Minutes
Board Meeting – September 14, 2020

An update on the construction of Piney Woods Elementary School was given by Dan Neal, consultant, and Greg Hughes, of Contract Construction. A discussion regarding concrete testing took place between board members and included questions directed to Mr. Neal, Mr. Hughes, Mr. (Doug) Quackenbush, of Quackenbush Architects, and Mr. (Mike) Montgomery, of Montgomery Willard, LLC.

ES No. 13
 814 Amicks Ferry Road
 Chapin, SC

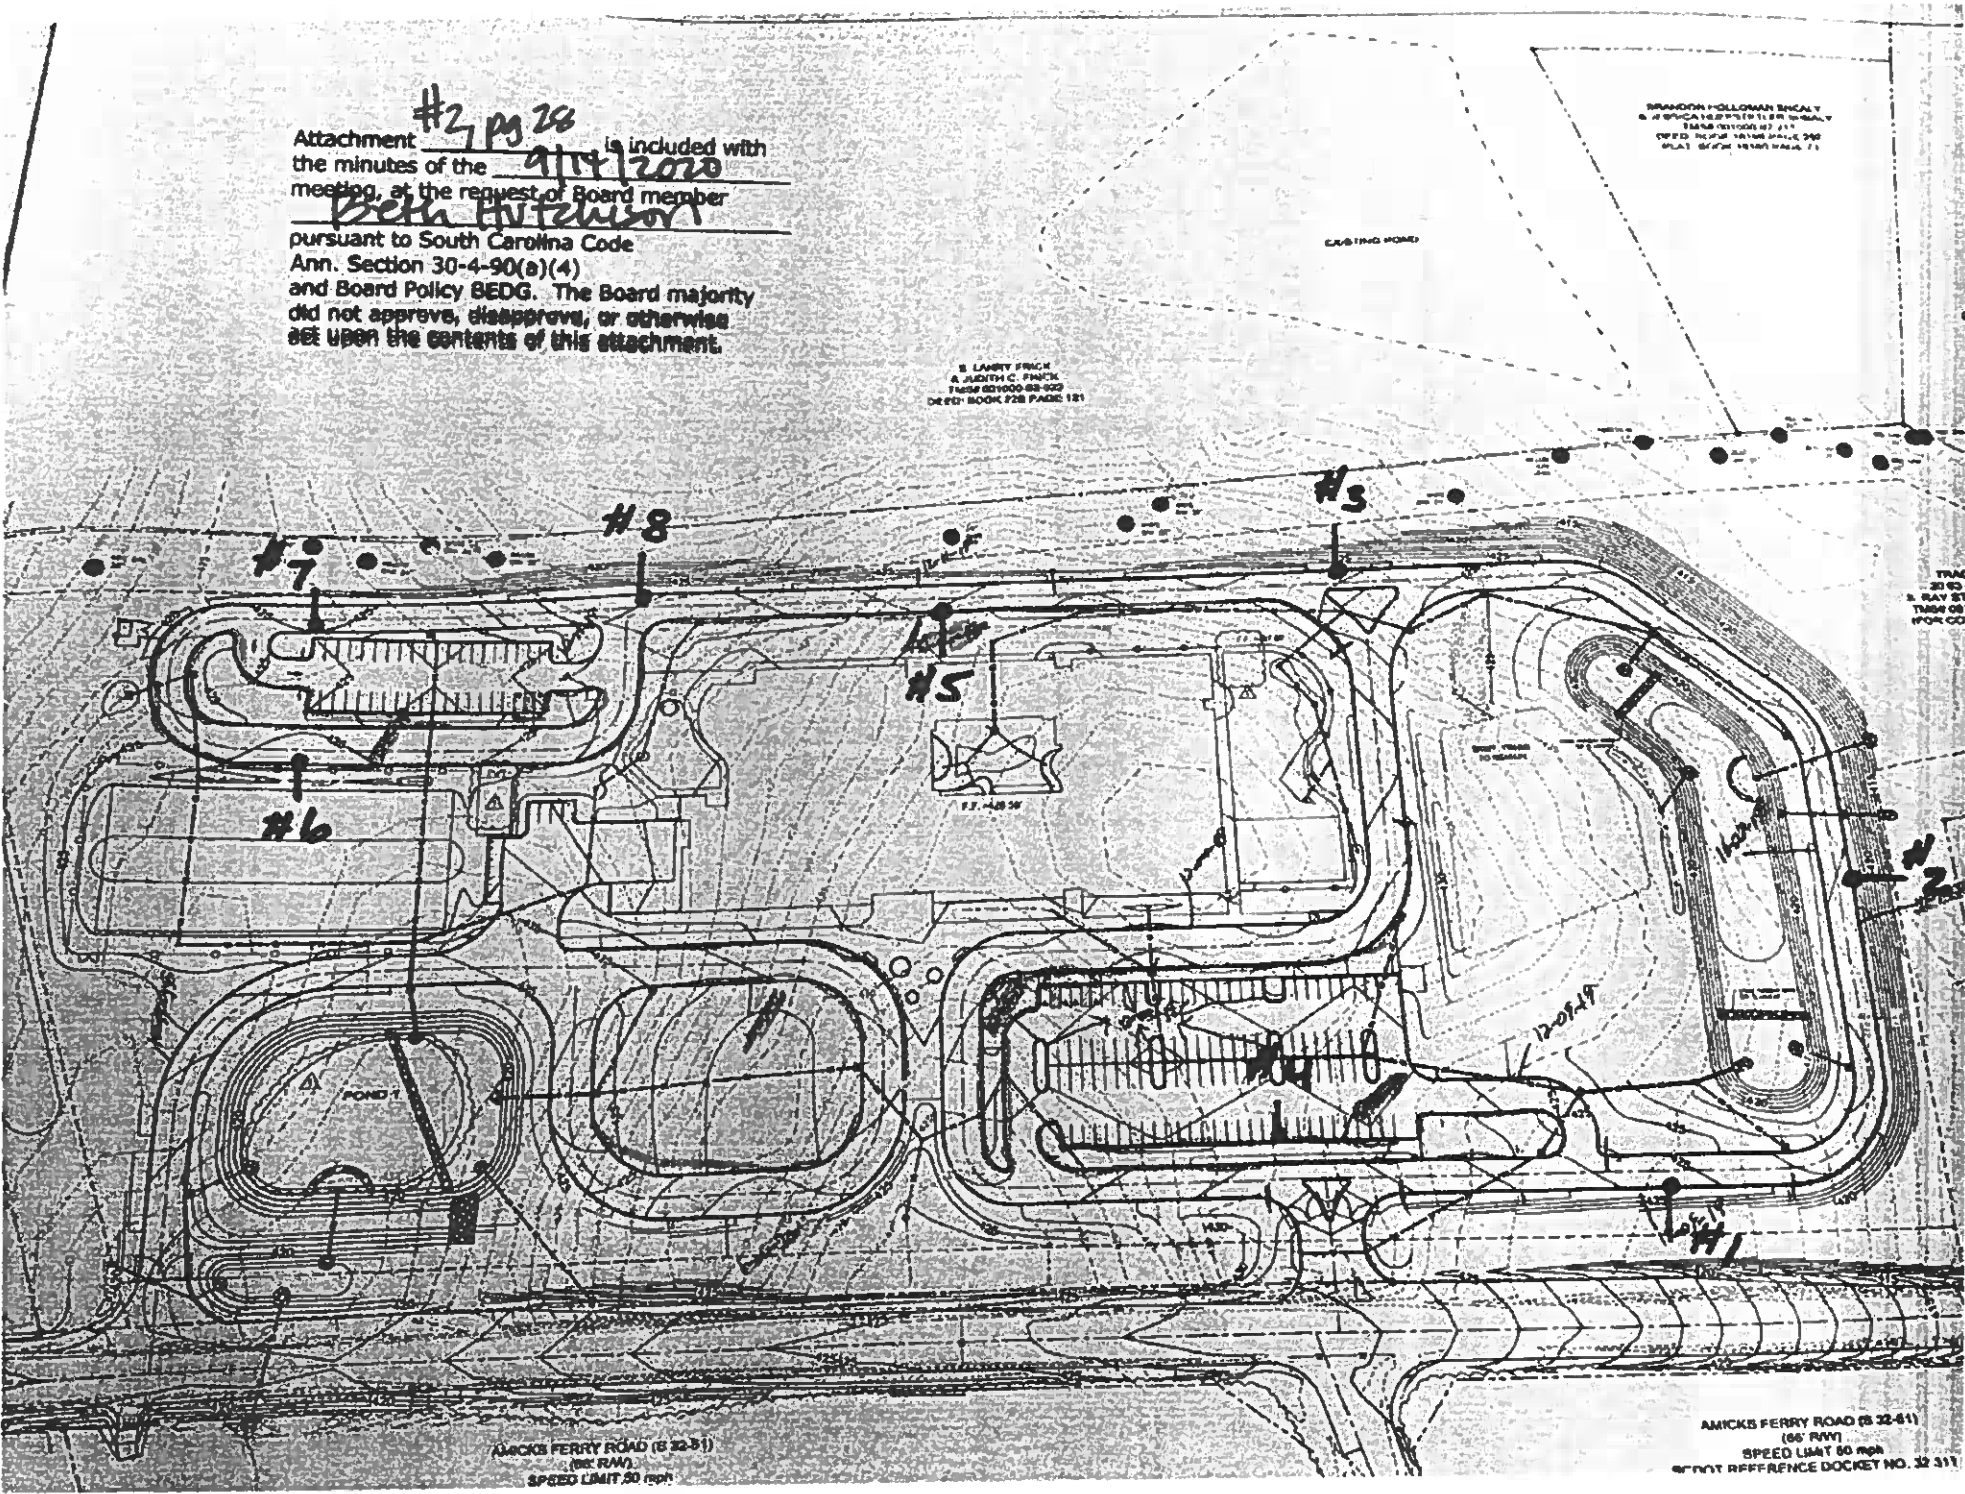
I have attached the submittals for the Amick's Ferry Elementary School project for Coogler Construction, and the rebound hammer test and locations for your review. The mix design submitted for curb is F30CCSFM. This mix design has Delvo, a hydration stabilizer, built into the mix to provide additional placement time. In addition to Delvo, the customer requested a dose of retarder on several of the pours. The retarder gives concrete an extended time of plasticity, while the Delvo will stop hydration for a period of time. Knights was confident that with these products and the ambient temperatures being what they were, that the performance of the concrete would be fine with an extended delivery time.

Date of Testing:	7/23/2020		Design Strength Tested:	3000 Psi.
Mix Design:	F30CCSFM			
Orientation:	V	V	V	V
Surface Condition	Broom	Broom	Broom	Broom
	Rough	Rough	Ground	Ground
Location	#5	#6	#7	#8
Test Number	5	6	7	8
1	38	42	40	44
2	38	40	40	40
3	38	40	38	40
4	38	44	38	42
5	38	40	40	40
6	40	42	38	40
7	36	42	40	40
8	38	40	42	40
9	38	42	40	42
10	38	40	40	38
11	36	40	38	38
12	38	40	40	40
Average	38	41	40	42
Adjusted Average	38	41	40	42
Compressive PSI	4370	4715	4600	4830

The results from the Rebound Hammer show that the in place concrete exceeds the design strength. The results also show that the concrete strength is very consistent between the locations tested.
